UNITED STATES PATENT AND TRADEMARK OFFICE

APPLICATION NO.	FILING DATE	FIRST NAMED INVENTOR	ATTORNEY DOCKET NO.	CONFIRMATION NO.
10/767,225	01/28/2004	Yi-Lung Kuo	23724-07838	2599

Office Action Summary	Application No. 10/767,225	Applicant(s) KUO, YI-LUNG	
	Examiner Noah C. Hawk	Art Unit 3636

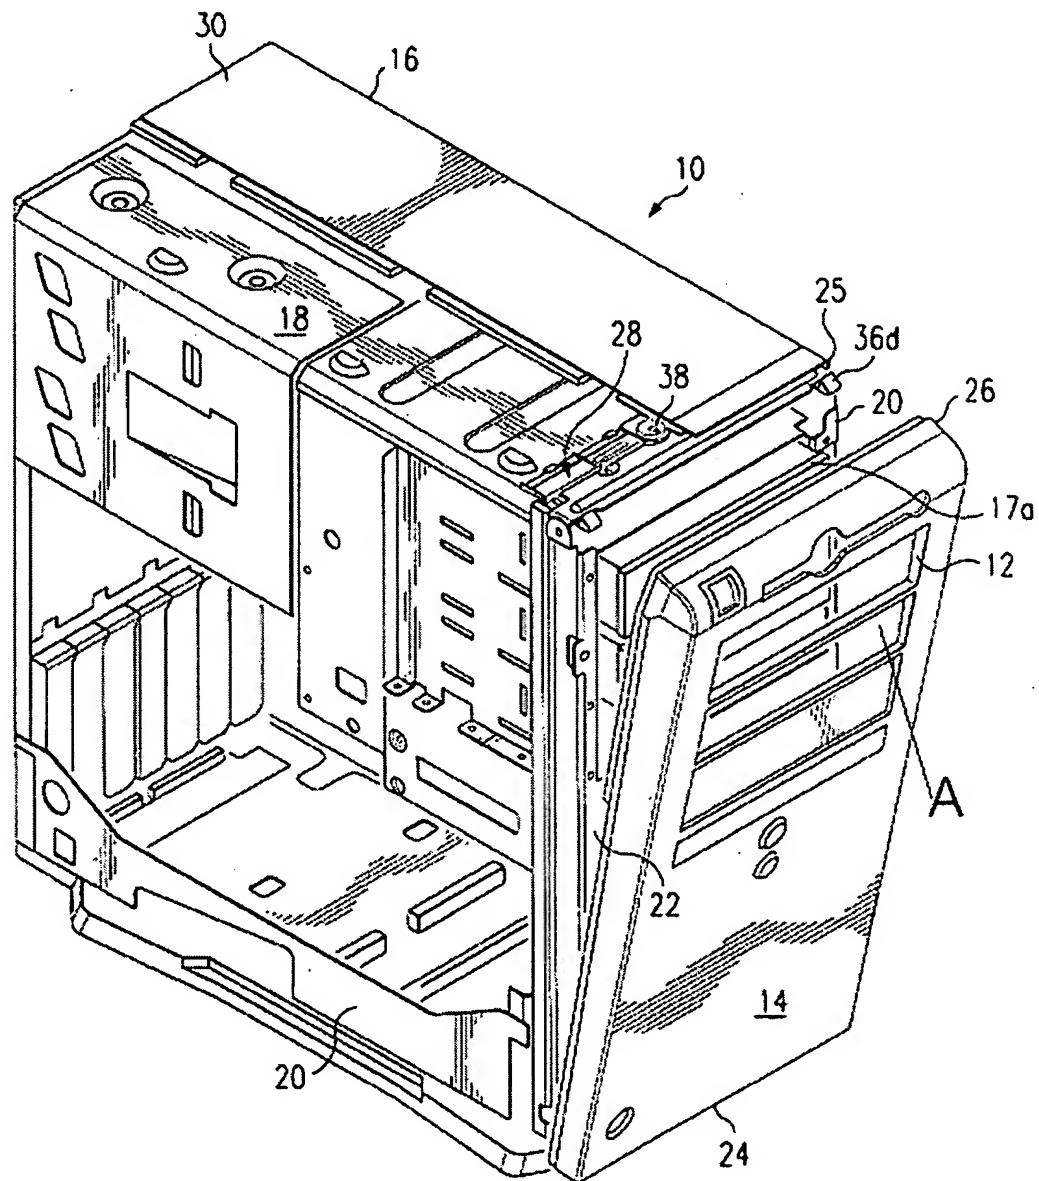
4. Claims 1, 3-7, 9, and 22-28 are rejected under 35 U.S.C. 112, first paragraph, as failing to comply with the enablement requirement. The claim(s) contains subject matter which was not described in the specification in such a way as to enable one skilled in the art to which it pertains, or with which it is most nearly connected, to make and/or use the invention. Claim 1 recites the limitation "the cover plate including a window that allows access to a at least one of the drives when the cover plate is in the closed position." In Figure 2 of the applicant's specification, the cover plate and window are both shown closed and there is no way to access any of the drives covered thereby. It is unclear how the applicant intends for the cover plate or window to allow access to a subset of the drives.

Radloff et al., Figure 2

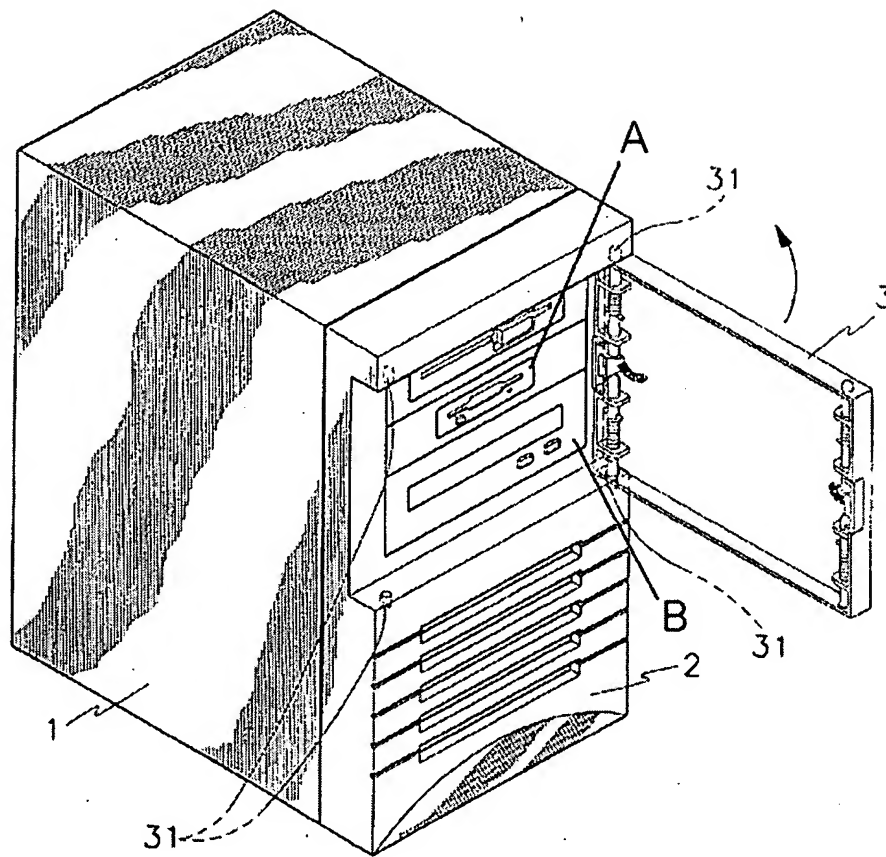
a. Regarding Claims 1 and 4, Radloff teaches a face plate apparatus comprising an opaque cover plate (14) having a window (A) and a mechanism ("pivotally attached" see Column 3, lines 14) for rotatably coupling the cover plate to a computer chassis (10) about a first axis (a horizontal axis). Radloff fails to teach a drive door to cover the window. Dong teaches a drive door (14) rotatable about a second (horizontal) axis and covering a window (12) in a cover plate (10) to further protect the drives underneath. It would have been obvious to one of ordinary skill in the art at the time of invention to modify the device of Radloff by adding a drive door as taught by Dong in order to further protect the drives under the cover plate.
